Access Compliance Report

Public Rights-of-Way

(Curb Ramps)

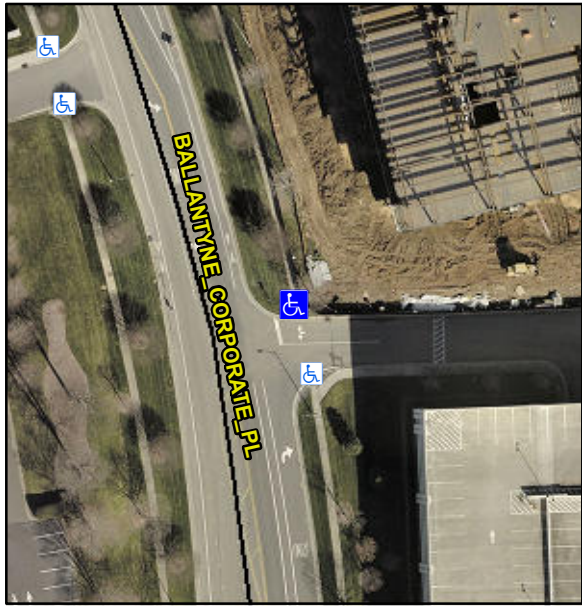
Intersection ID: 10020374		Main Street: BALLANTYNE CORPORATE PCross Street: N/A		Location: N															
ADA ID: D924A3600F56		Ramp Type: Directional1		Initial Pass/Fail: Fail		Overall Compliance: No		Severity Score: 1.25											
Codes/Mitigation Info/Possible Solution				Field Measurements/Component Compliance															
<div></div> <div>Street 1 NameENTRANCE</div> <div>Stop Condition-Street 1StopSign</div> <div>Street 2 NameN/A</div> <div>Stop Condition-Street 2N/A</div>				Possible Solutions:		Compliance		Description		Data		Compliance		Description		Data			
				Remove & Replace Entire Ramp.		N/A		Ramp Length (in)		77.0		N/A		Grade Break?		N/A		N/A	
						Yes		Ramp Width (in)		48.0		N/A		Grade Break Slope (%)		0.0		0.0	
						Yes		Ramp Slope (%)		2.2		N/A		Grade Break XSlope (%)		0.0		0.0	
						No		Ramp XSlope (%)		4.1									
						N/A		Flare Type LT		N/A		N/A		Flare Type RT		N/A		N/A

R304.5.3

Remove & Replace Entire Ramp.
